Prairie Island Nuclear Generating Plant
License Amendment Request Dated January 13, 1986

Evaluation of Proposed Changes to the
Technical Specifications Appendix A of
Operating License DPR-42 and DPR-60

Proposed Changes Marked Up
on Existing Technical Specification Pages

SAFETY LIMITS, REACTOR CORE,
 THERMAL AND HYDRAULIC
 TWO-LOOP OPERATION
 FIGURE TS.2.1-1

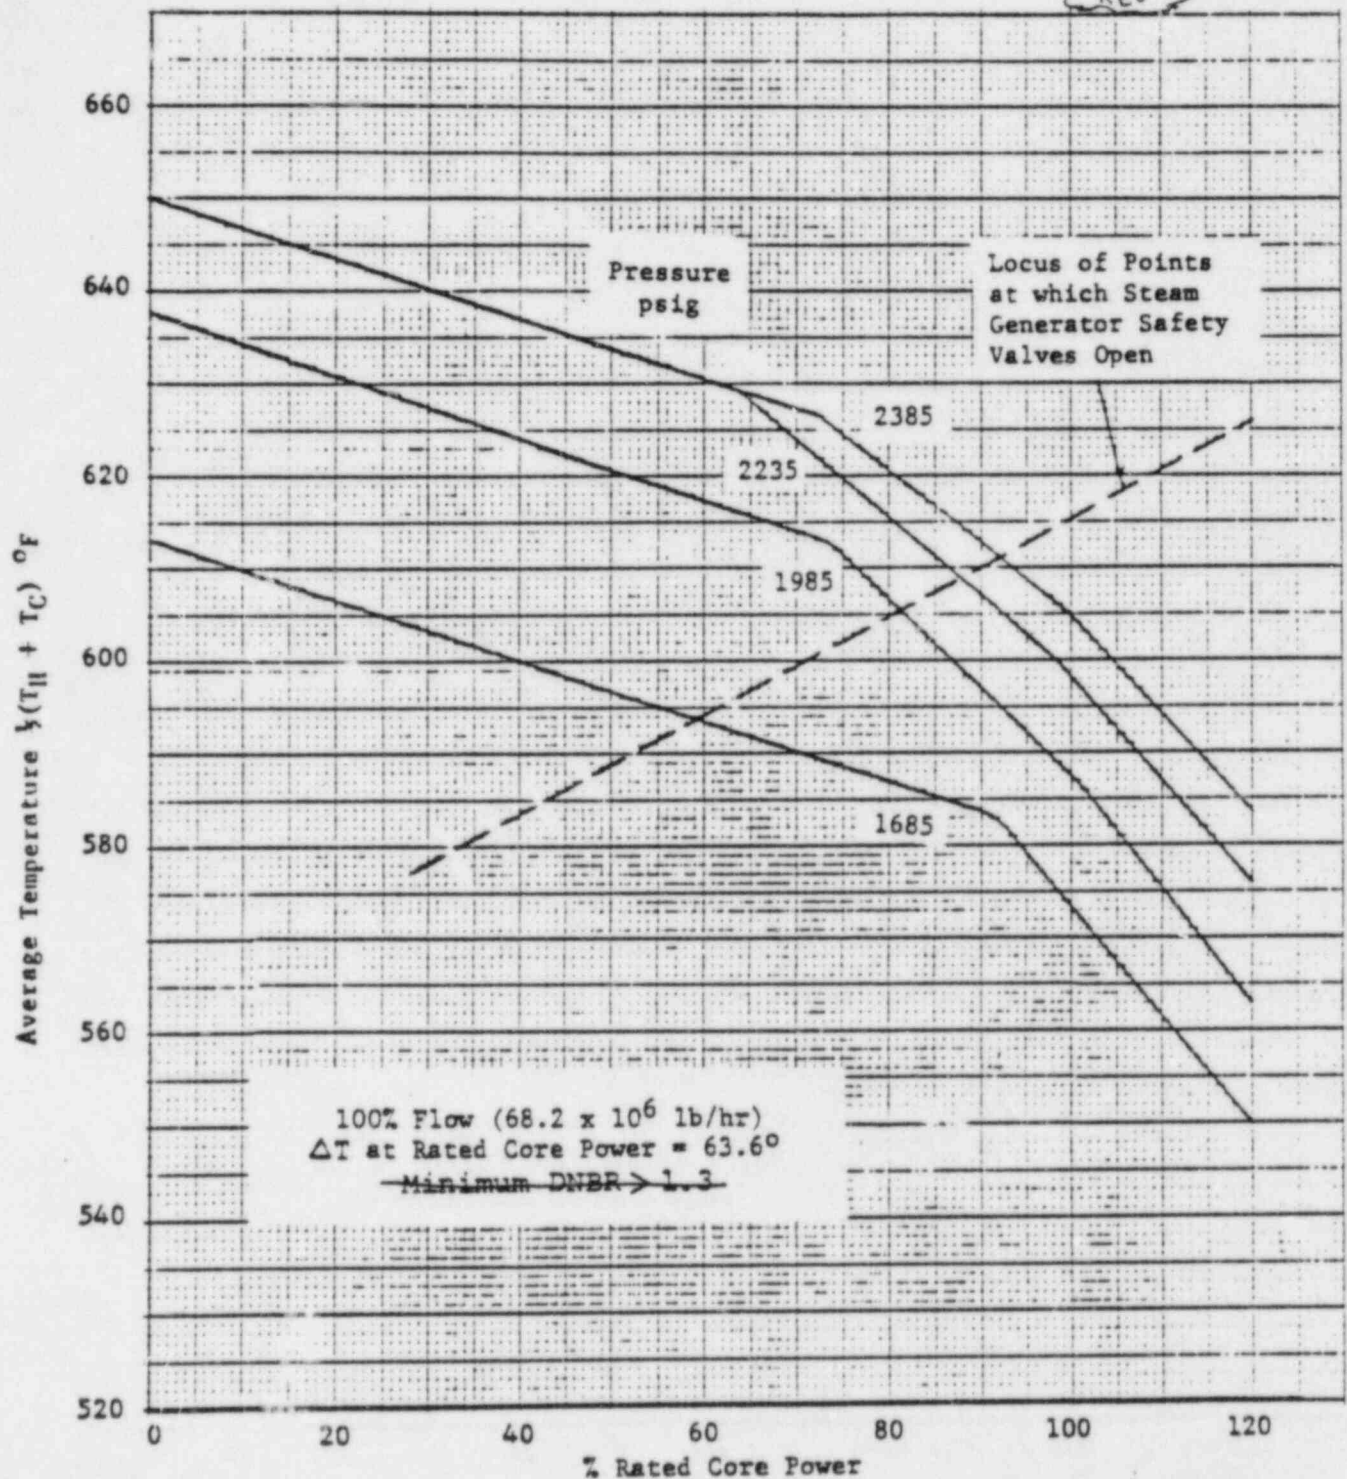
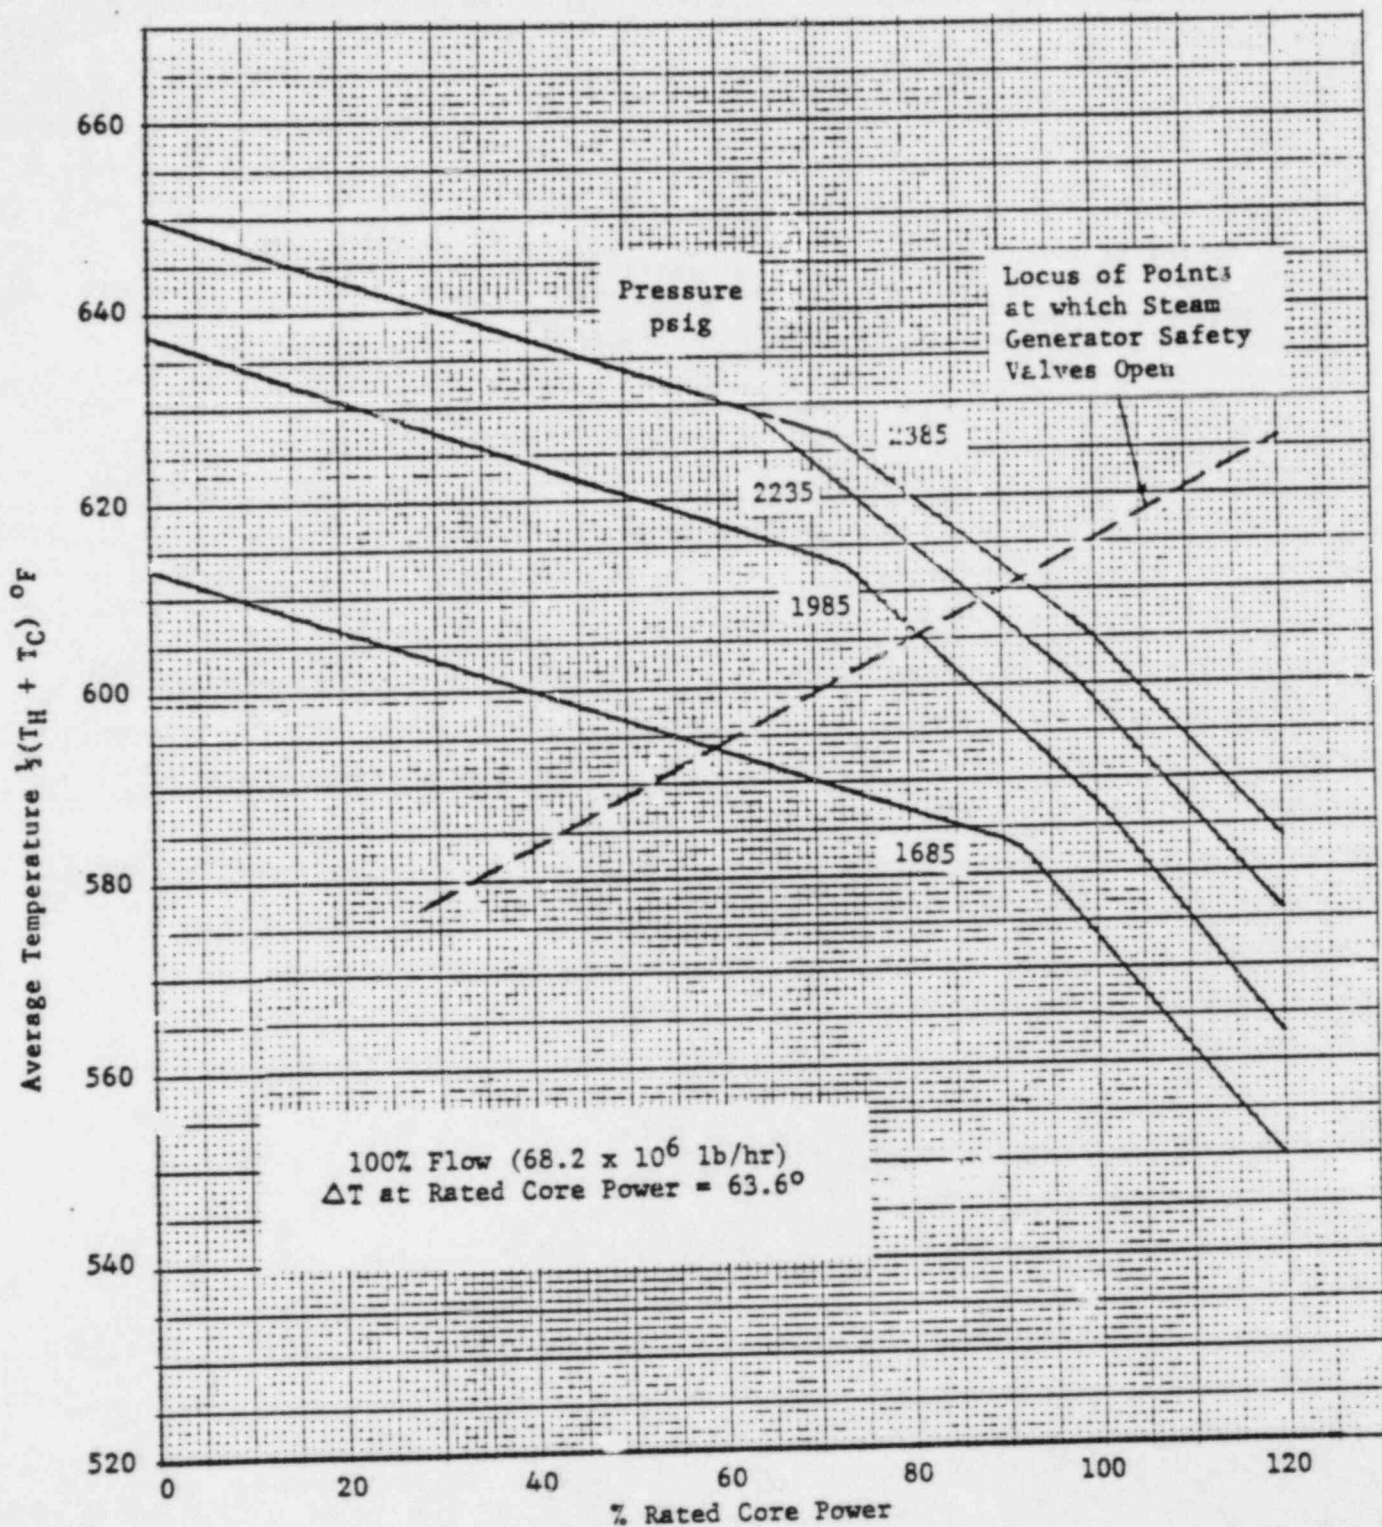
Add reference to the WRB-1 DNB correlation for Westinghouse fuel and identify that the W-3 DNB correlation will be used for Exxon fuel.

Pages affected: TS.2.1-1, 2, 3, TS.2.3-6, TS.3.10-8, TS.3.10-13, Figure TS.2.1-1 (The bases on existing page TS.2.1-3 will be moved to proposed page TS.2.1-2. Therefore, there is no page TS.2.1-3 in Exhibit C.)

FIGURE TS.3.10-5
REV ~~66~~ 10/3/83

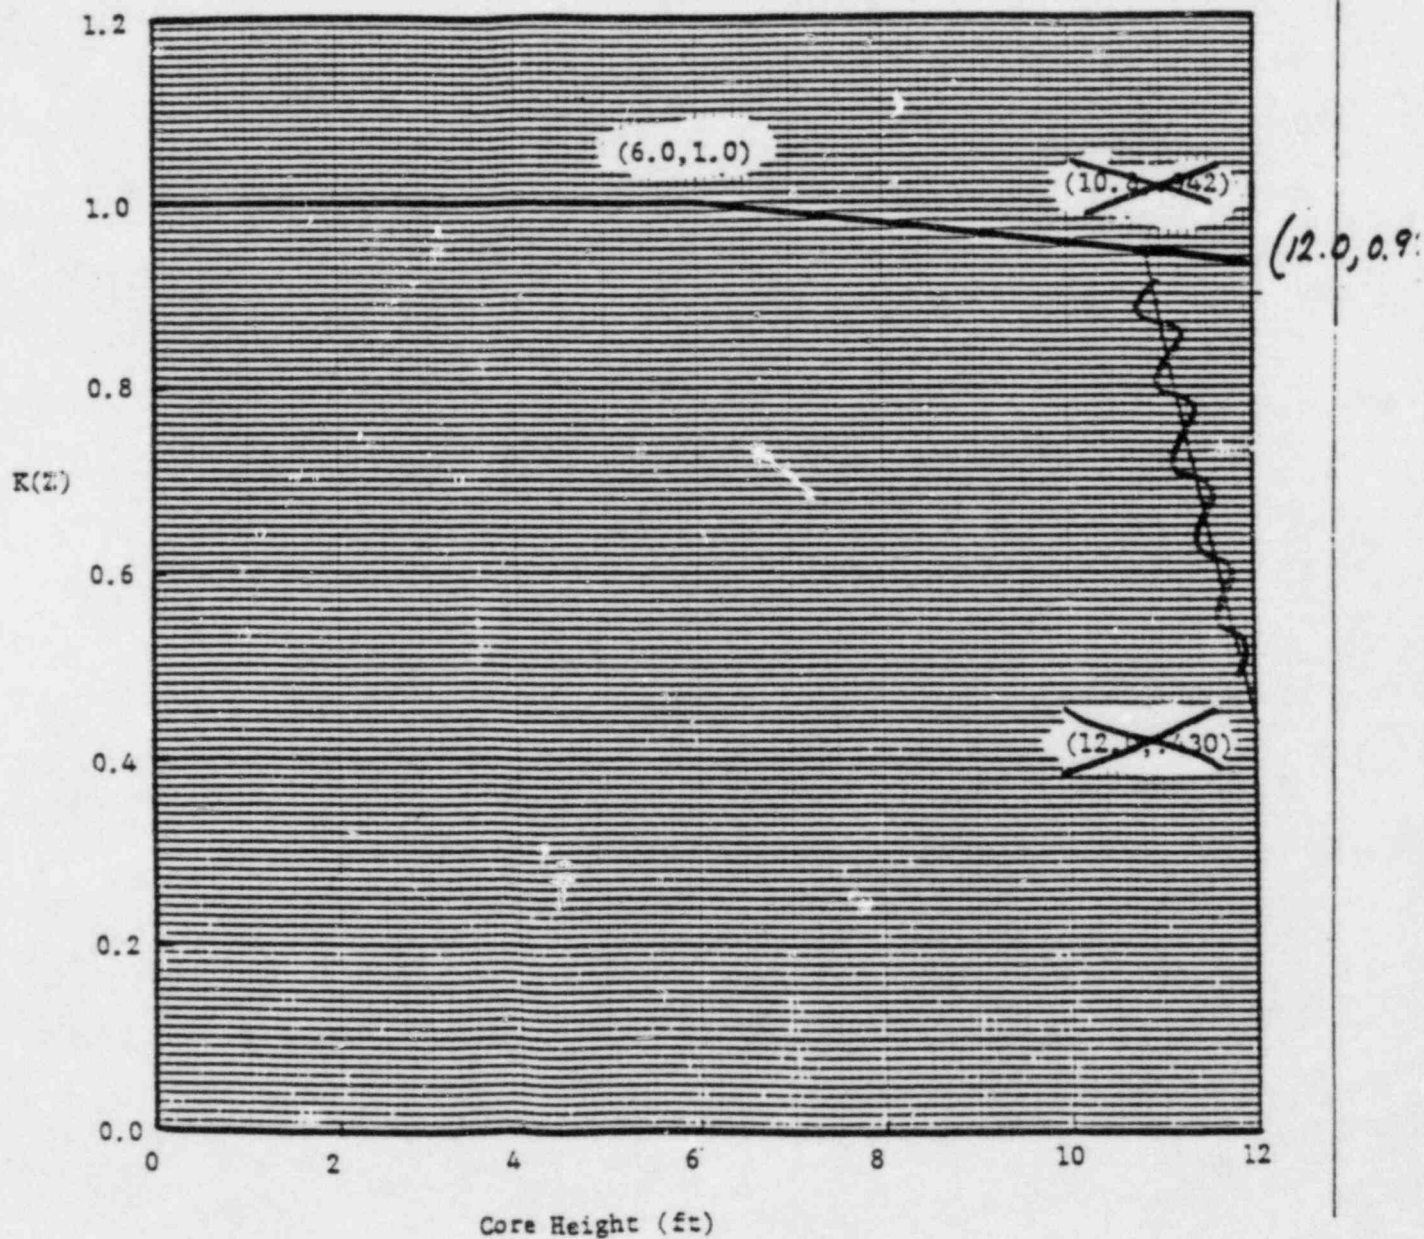
On Figure TS.3.10-5, delete the third line segment and extend the second line segment to the 12 foot level.

This change will allow more F_Q flexibility in the top of the core.

This change is supported by recent small break LOCA analyses performed by Westinghouse on Westinghouse and Exxon fuel assemblies. The Westinghouse fuel analysis is contained in Exhibit F and the Exxon fuel analysis is contained in Exhibit G. Both analyses show that the small break LOCA peak cladding temperature is approximately 1000°F and support the removal of the third line segment of the K(z) curve.

FIGURE TS.3.10-7
REV 67 12/28/83

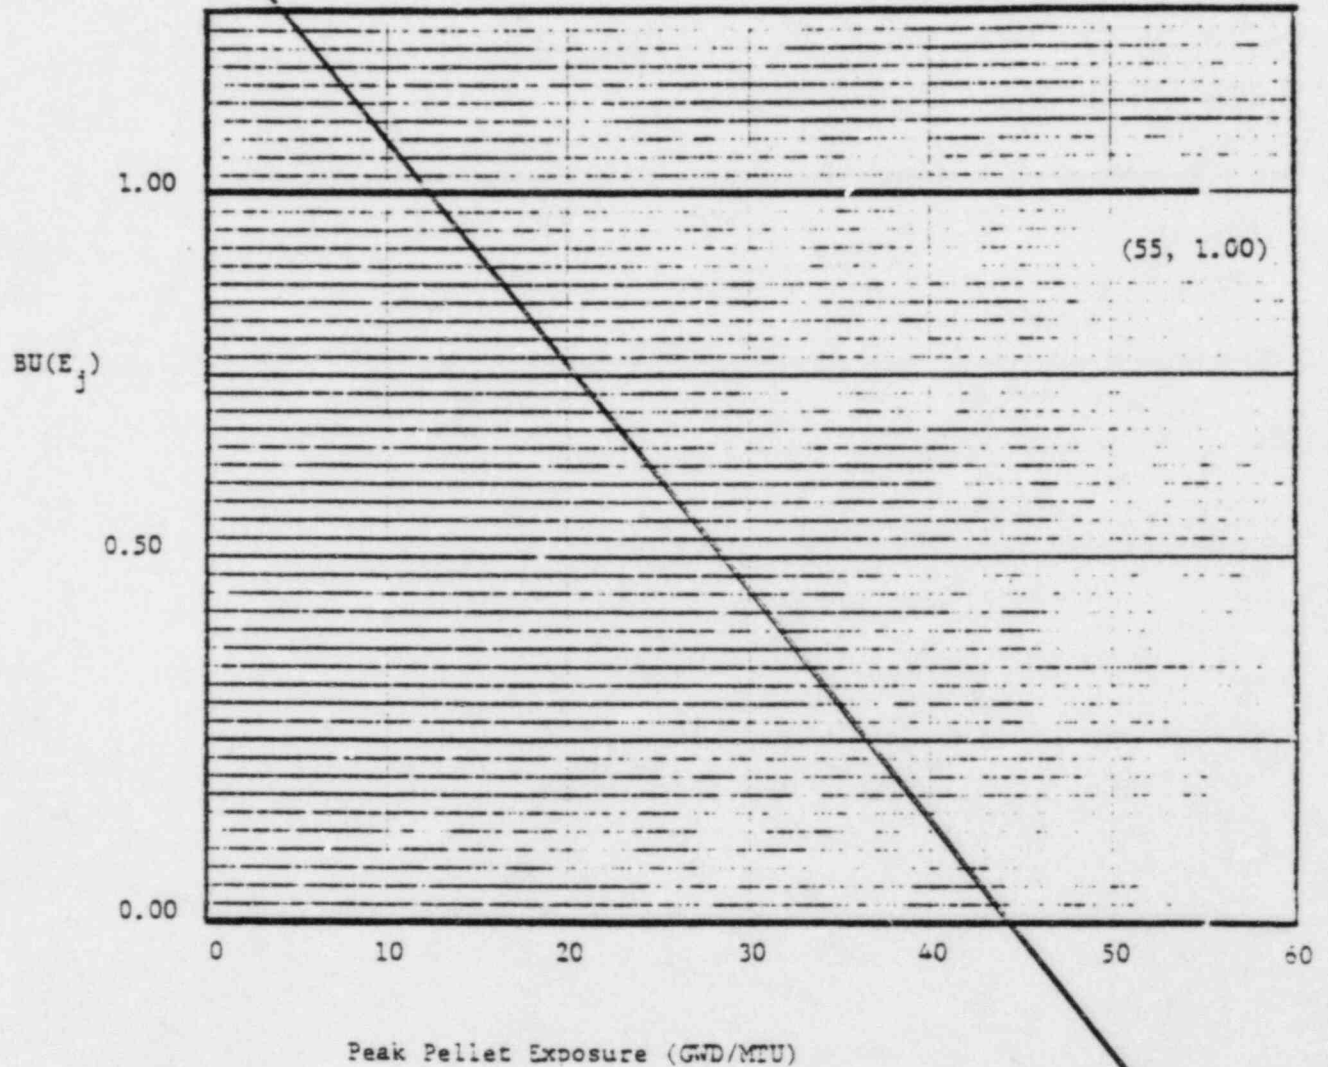
Delete Figure TS.3.10-7, renumber the next sequentially numbered curve and delete references to the curve.

The normalized exposure dependent function, $BU(E_f)$ was used for Exxon Nuclear fuel. Since this value of this function is one for all burnup values up to 55 GWD/MTU, it can be deleted.

DELETE

FIGURE TS.3.10-8
REV 34 4/20/79

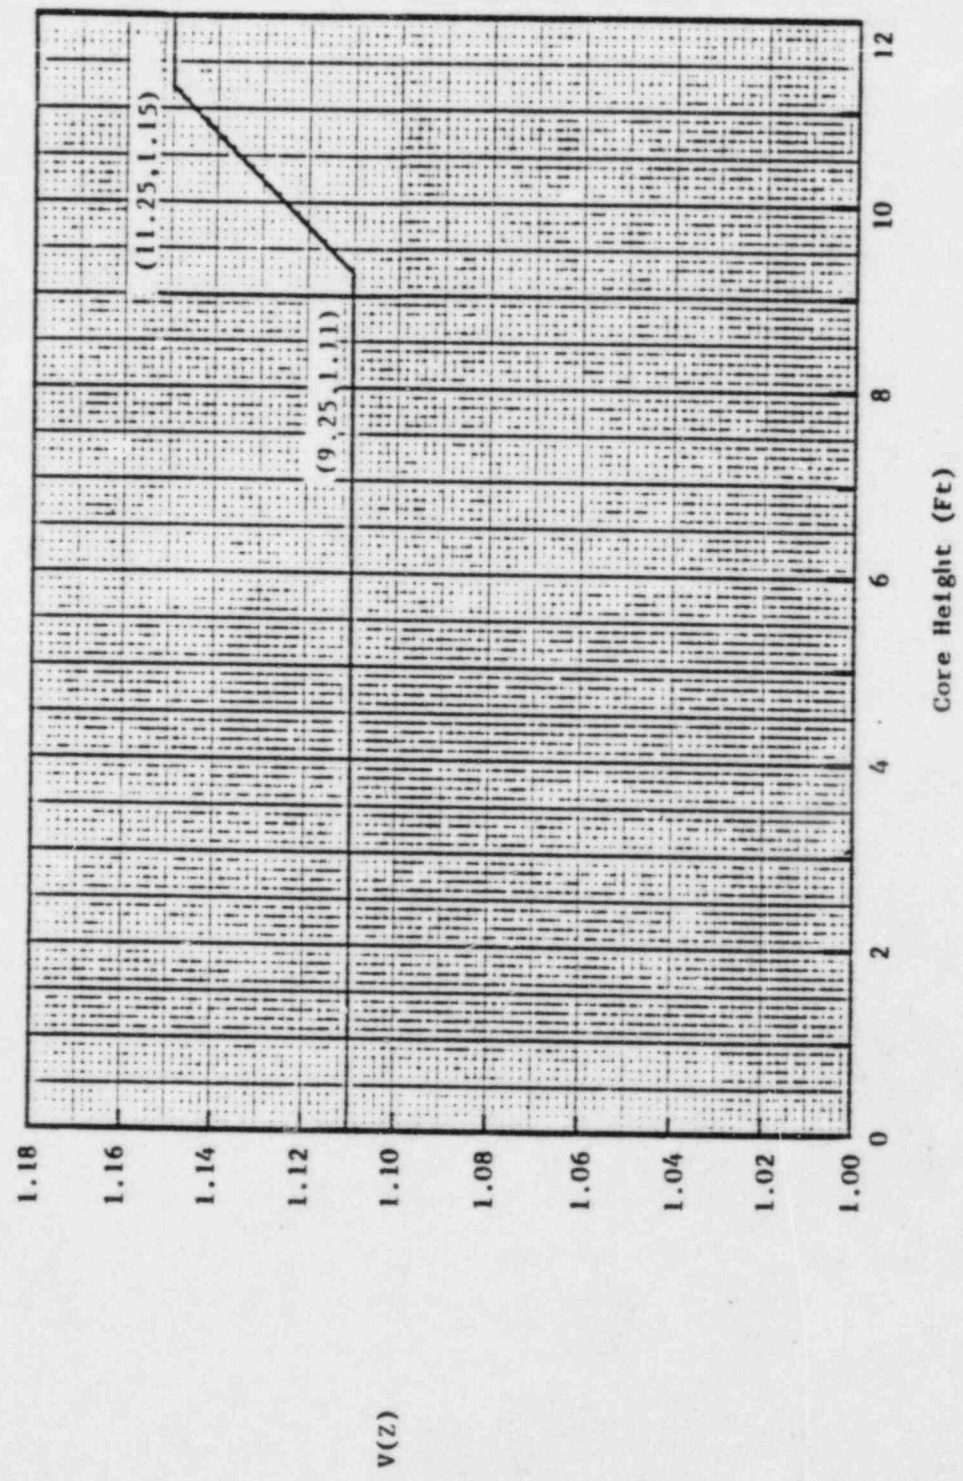
Redraw ↘

TS.3.10-7
